NUREG/CR--5347

Recommendations for Resolution of Public Comments on USI A-40, "Seismic Design Criteria"

Manuscript Completed: February 1989
Date Published: June 1989

Prepared by
A. J. Philippacopoulos

Fig. 1 Spectral Density Functions (Initial, Actual and Lower Bound); Parameter Set No. 2
(From Reference 3)

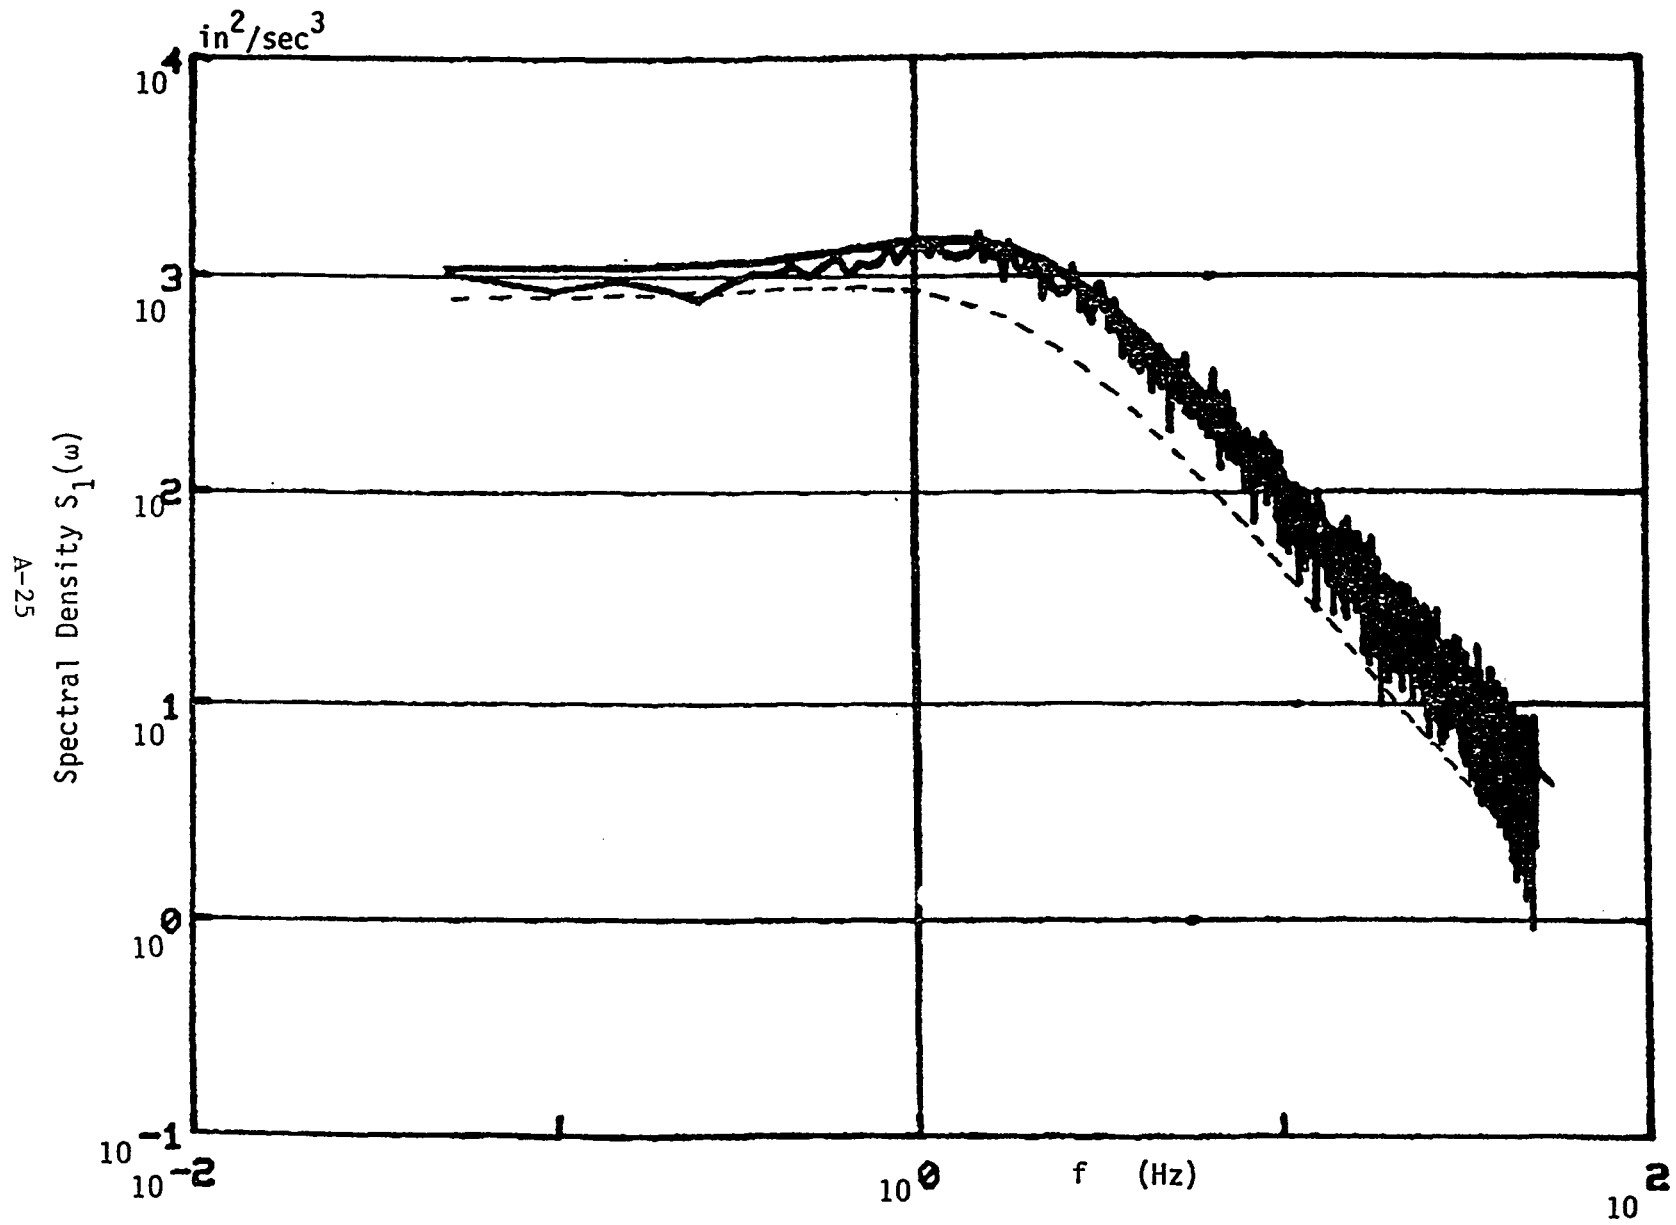
3. The average power over a $\pm 20\%$ frequency band width is compared to Equation (2.5) as opposed to comparing the average power over a 0.15 Hz band width with 85% of the power from Equation (2.1). Actual PSD plots have substantial peaks and valleys. In my opinion, it is the average power over a frequency band which is the important ground motion characteristic and not a very narrow (0.15 Hz), but deep valley. It is very difficult to produce a smooth PSD at frequencies above about 5 Hz (see Figure 1), and a requirement that a narrow 0.15 Hz

FIGURE 3. CUMULATIVE SPECTRAL DENSITY FUNCTIONS OF EFFECTIVE ACCELEROGRAM SEGMENT DEFINED BY $T'_D = T_m - T_{.05}$ (Reproduced from Ref. 4)

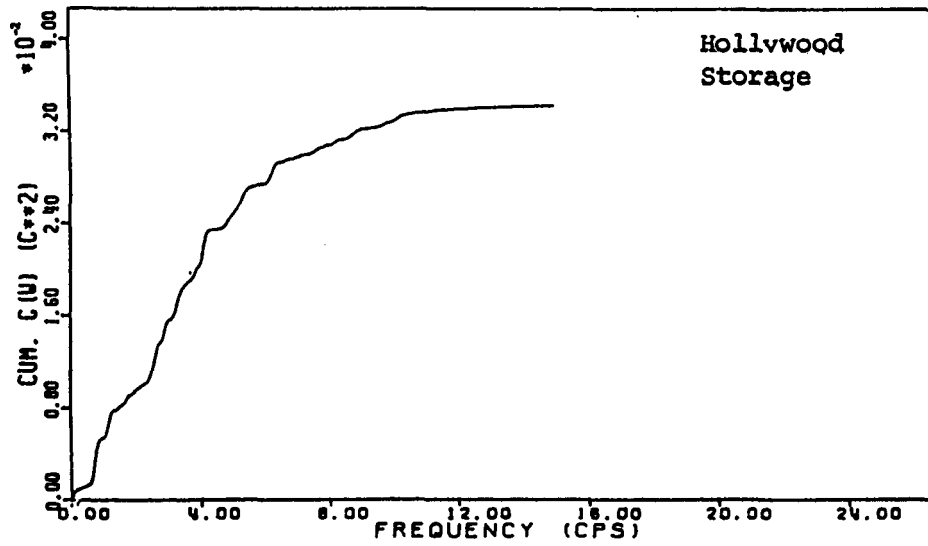
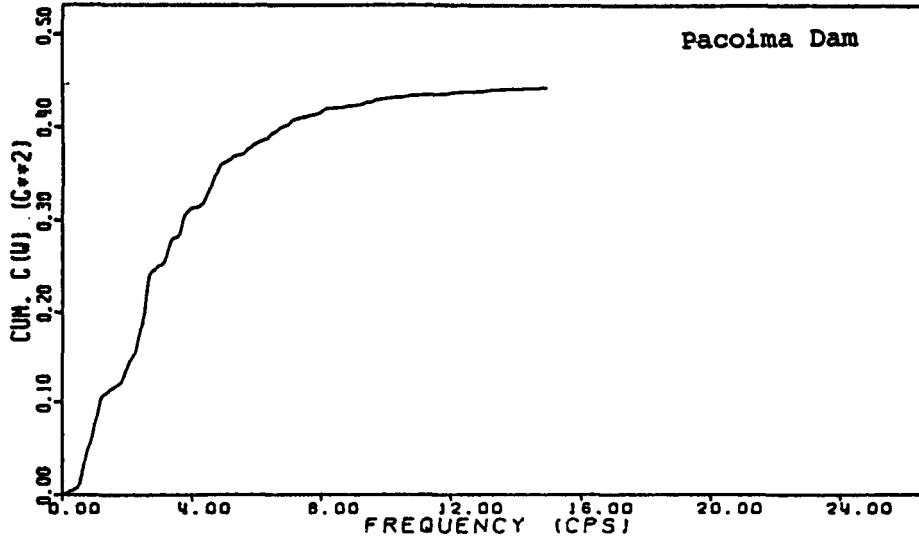
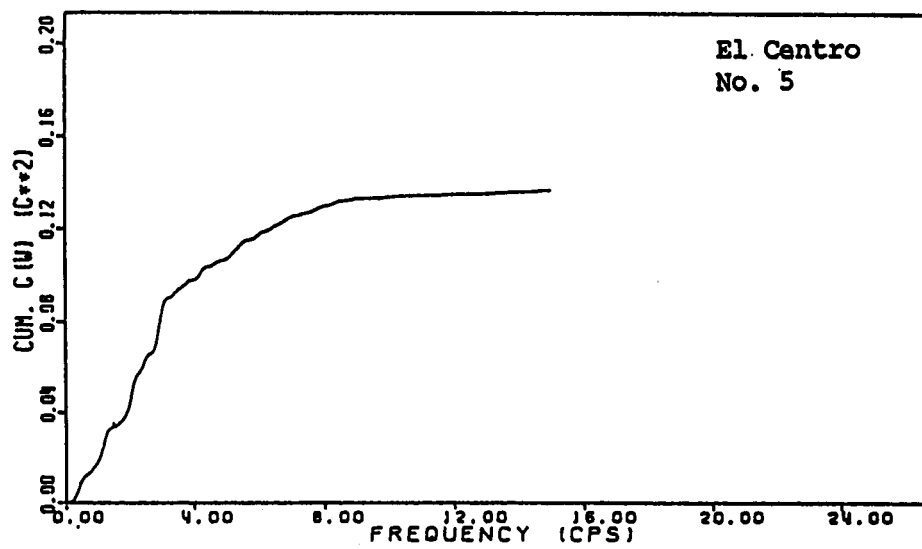
Figure 3 presents plots of the Cum PSD for each of these seven records, as reproduced from Reference (4). All seven of these records have similar characteristics, which accounts for the similarity in elastic and inelastic response produced by these records. These characteristics are:

1. Negligible power above about 12 Hz (see slope of Cumulative PSD curves in Figure 3)
2. Scaled Cumulative PSD between $0.49g^2$ and $0.71g^2$ for an effective peak acceleration of 1.0g
3. f_{10} between 0.55 and 1.20 Hz; f_{50} between 2.15 and 3.30 Hz; f_{90} between 5.50 and 7.90 Hz

Based upon a review of the Cumulative PSD plots presented in Figure 3 and the power characteristics given in Table 1, I recommend the following revised PSD requirements. From 0.4 Hz to 15 Hz, the average one-sided PSD over any $\pm 20\%$ frequency band width centered on a frequency f (i.e., 4 to 6 Hz band width for $f = 5.0$ Hz) computed over the strong motion duration should exceed:

FIGURE 5. ACCELEROGRAM AND CORRESPONDING CUMULATIVE ENERGY FOR THE EL CENTRO, ARRAY NO. 12, IMPERIAL VALLEY 1979 (140) RECORD (From Ref. 4)

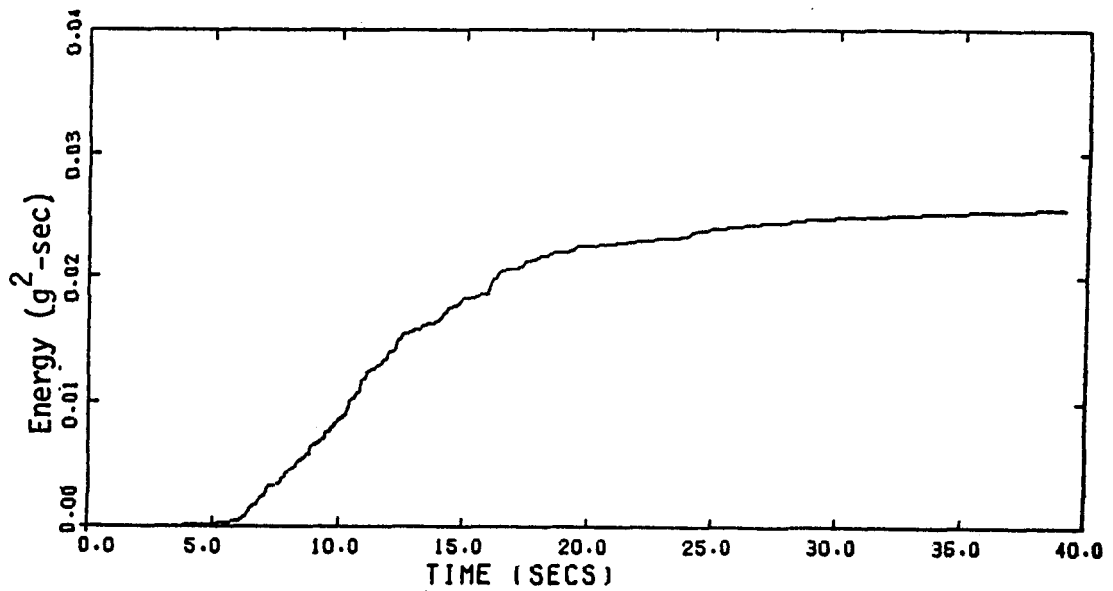
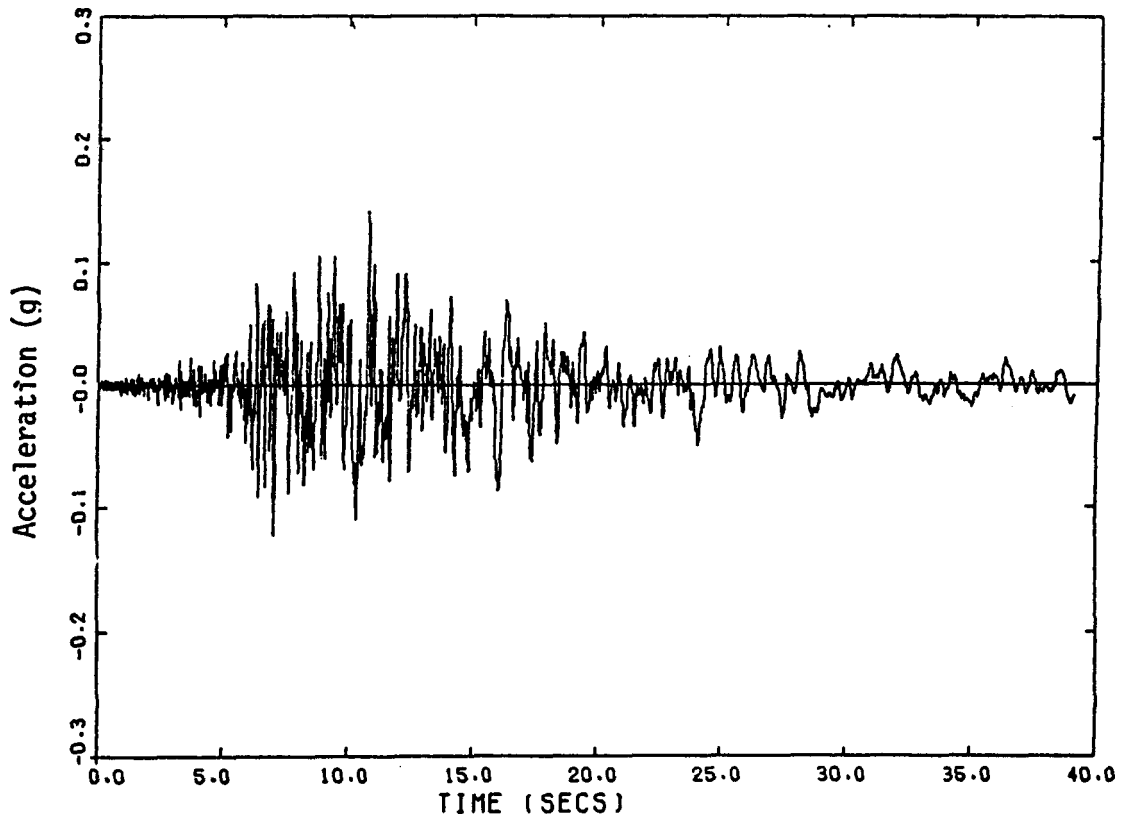
where $A(t)$ is the acceleration at time t . Figure 5 shows a cumulative energy plot from a representative time history. All seven time histories listed in Table 1 produce cumulative energy plots similar to that shown in Figure 5. For most time histories, Reference (4) recommends that the strong motion duration, T_D (duration of near maximum power) can be defined by:

where $T_{0.75}$ and $T_{0.05}$ are the times at which 75% and 5%, respectively, of the cumulative energy are reached. For the time history shown in Figure 5 (El Centro #12), this strong motion duration is 9.6 seconds. For the six actual records listed in Table 1 which produce spectra similar to the R.G. 1.60 response spectrum, T_D ranges from 3.4 to 15.6 seconds. In my opinion, time histories consistent with the R.G. 1.60 response spectrum should have strong motion duration based upon Equation (3.2) of 5.0 to 16.0 seconds.

Figure 5. RECOMMENDED MINIMUM POWER SPECTRAL DENSITY REQUIREMENT (PSD3)

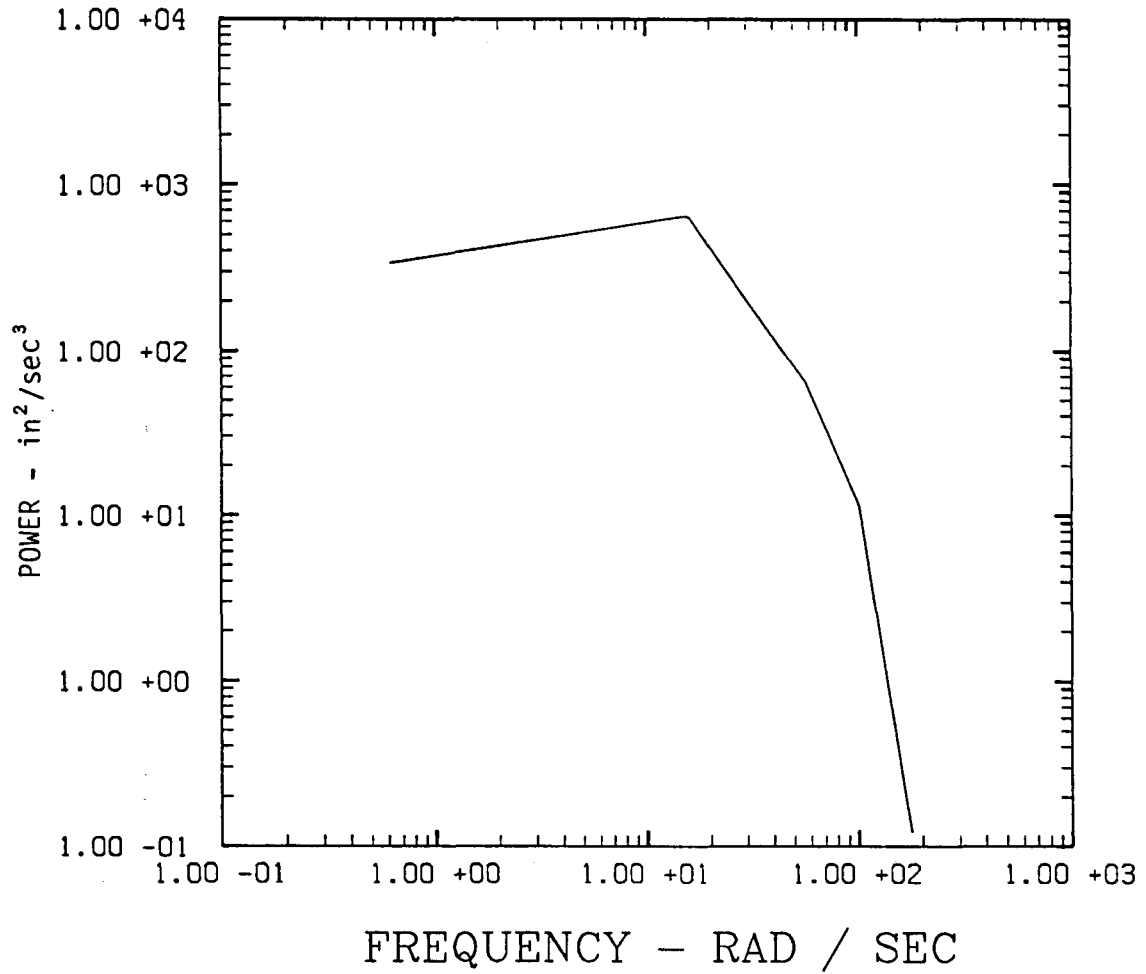
The PSD requirement defined for PSD 3 by Equation (11) is shown in Figure 5 while the relative cumulative power for PSD 3 is shown in Figures 6 and 7. The f_{10} , f_{50} , and f_{90} frequencies are about 0.7 Hz, 2.6 Hz, and 8.1 Hz, respectively, as noted in Table 1. The f_{10} and f_{50} frequencies are consistent with those obtained for the broad frequency content ground motion records also listed in Table 1, while f_{90} is only slightly higher than the highest f_{90} listed for the actual records in Table 1. If anything, PSD 3 may be slightly too broad in its high frequency content. However, a slight error in this direction is prudent for stiff nuclear plant structures.

To produce a response spectrum that conservatively envelopes the 1.0g RG 1.60 Response Spectrum at 2% damping and greater, we recommend the use of a PSD set at 130% of PSD 3 defined by Equation (11) with the resulting time history being clipped at $\pm 1.0g$. Following this recommendation will result in a response spectrum 14.0% greater than that shown in Figure 13 at frequencies less than about 23 Hz and equal to that shown at frequencies greater than about 33 Hz.

Figure 12. PSD OBTAINED FROM CLIPPED VERSUS NON-CLIPPED TIME HISTORIES

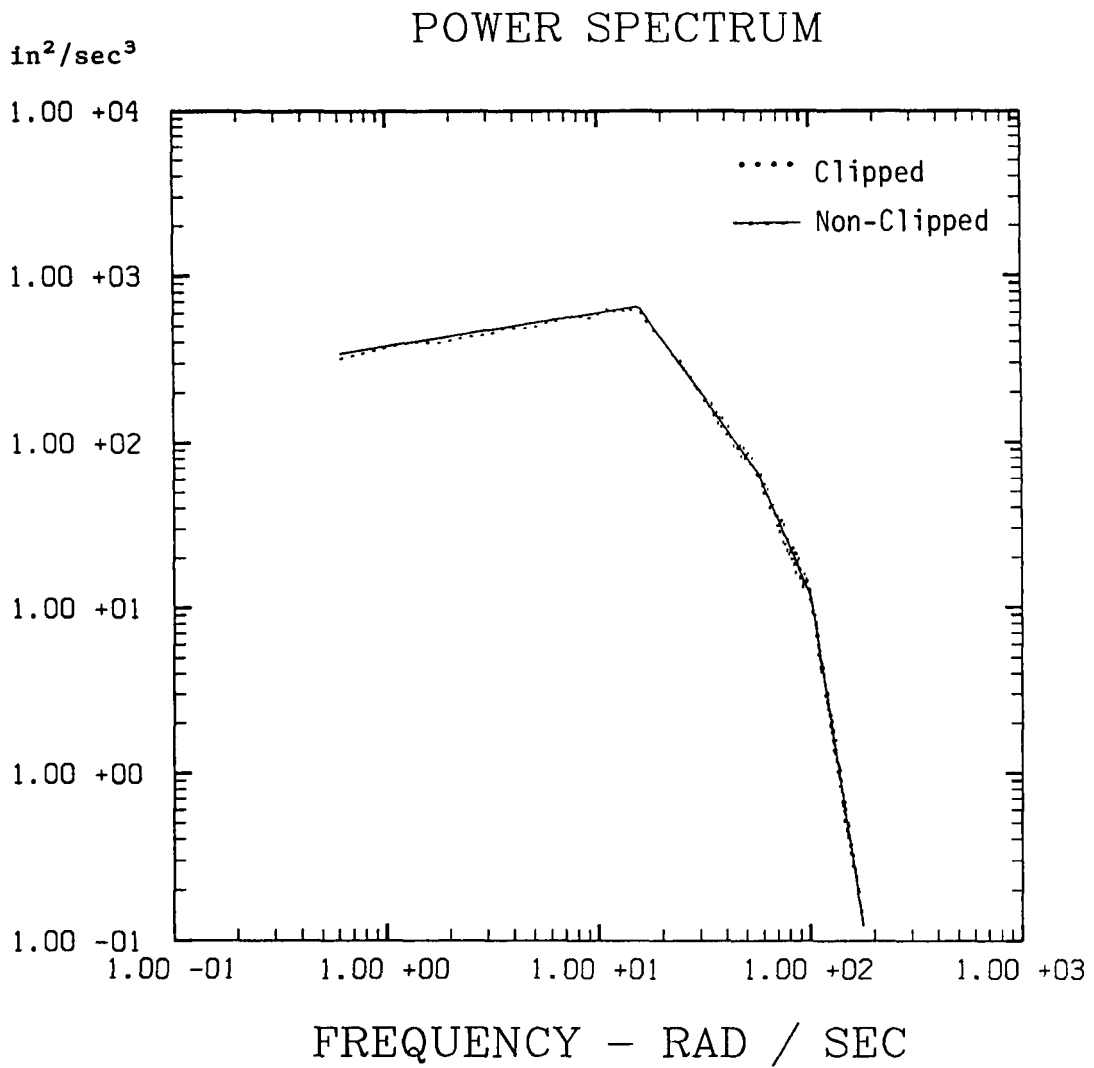
Figure 12 shows the resulting PSD obtained when the time history shown in Figure 10 based on PSD 3 has the one peak which exceeds 1.0g clipped at 1.0g. Figures 13 and 14 show the 2% damped PSRV response spectrum obtained when the time histories are clipped at 1.0g. Note that the exceedances of the RG 1.60 Response Spectrum above 23 Hz have now disappeared.
